# Technical BULLETIN

2007: PZ50GT (8GK), PZ50FX (8GN), PZ50M (8GP), PZ50VT (8GJ)  
2008: PZ50 (8GC), PZ50GT (8GK), PZ50RT (8GN), PZ50MT (8GP), PZ50VT (8GJ)  
2009: PZ50 (8GC), PZ50GT (8GK), PZ50RT (8GN), PZ50MT (8GP), PZ50VT (8GJ)  
Ground Failure at Joint Connector

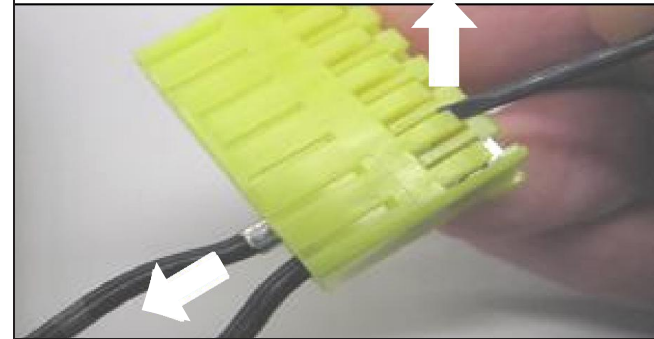
REMOVE TOP COVER.

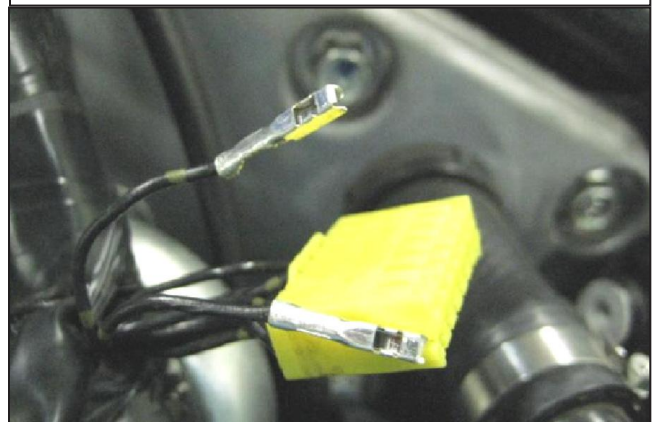
LIFT UP YELLOW TAB AND PULL WIRE OUT.

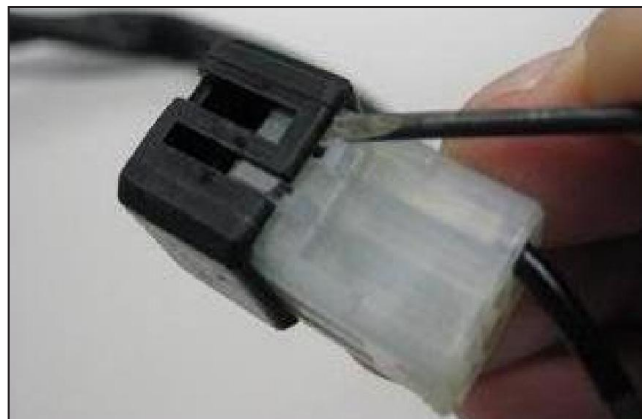
9. Connect the wires from #5 and 6 to the translucent 6-pin bus-bar connector:

- Remove the translucent connector black cap.

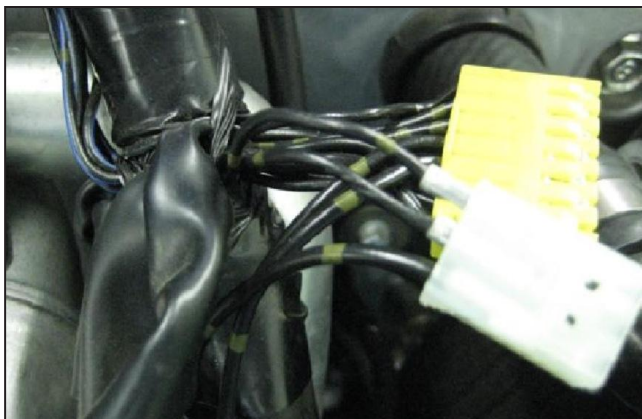
- Insert ground wires #5 and 6 from the unit's main harness next to the existing wire in the 6-pin connector.

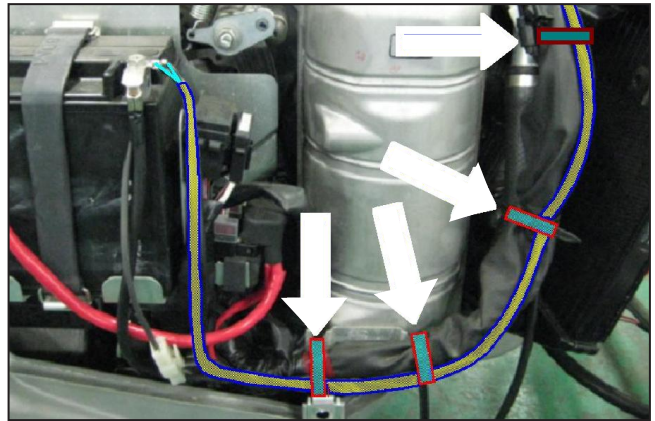
Ensure both connectors are positioned with the wires pointed down, then tape the sides and the top of the connectors (see adjacent photo).

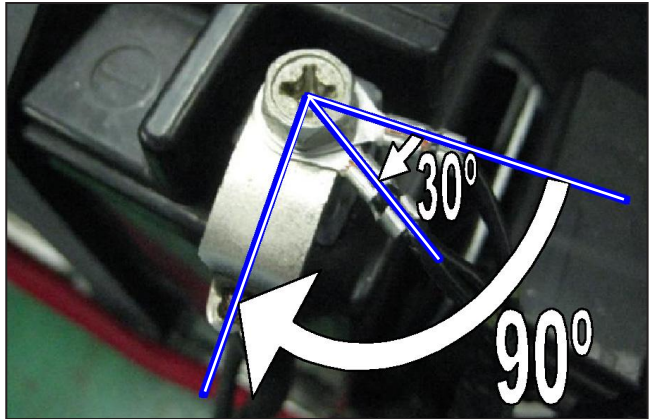
14. Connect the two eyelet connectors to the negative battery terminal as illustrated.

Make sure the wires are positioned on the negative battery terminal as shown in the adjacent photo to ensure a good ground.
